DART SERVICE INSTRUCTION

TO AMEND INSTALLATION INSTRUCTIONS D350-588 REV. D AND INSTRUCTIONS FOR CONTINUED AIRWORTHINESS ICA-D350-588 REV. 0 **REF TCCA STC SH92-41 FAA STC SH1012NE**

The purpose of this Dart Service Instruction is to provide customers with directions to install a modified striker plate that will provide more clearance around environmental/conductive seals that protrude inboard of the door frame structure on AS355 N/NP models.

Figure 1 Striker Plate

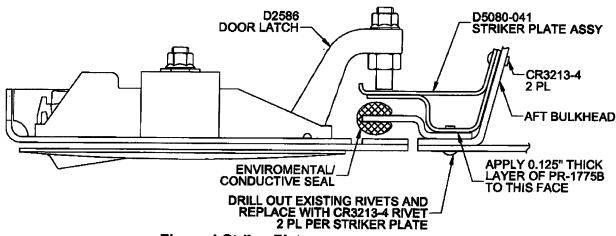
8) Deburr holes and remove all sharp edges.
9) Touch up all holes in aluminum with chemical conversion coating in accordance with MIL-DTL-5541.
10) Apply 0.125" thick layer of PR-1775B ProSeal to the face of D5080-041 per Figure 1.
11) Install D5080-041 striker plate assemblies to the aft bulkhead using CR3213-4 rivets of a suitable length, and to the skin of the aircraft using PR-1775B coated CR3213-4 rivets of a suitable length.
12) Reinstall environmental/conductive seal using manufacturers recommended procedure.
13) Install gas strut or cable assembly per D350-588 Figure 5.
14) Adjust both latch mechanisms to procure added to a seal and that does not be a
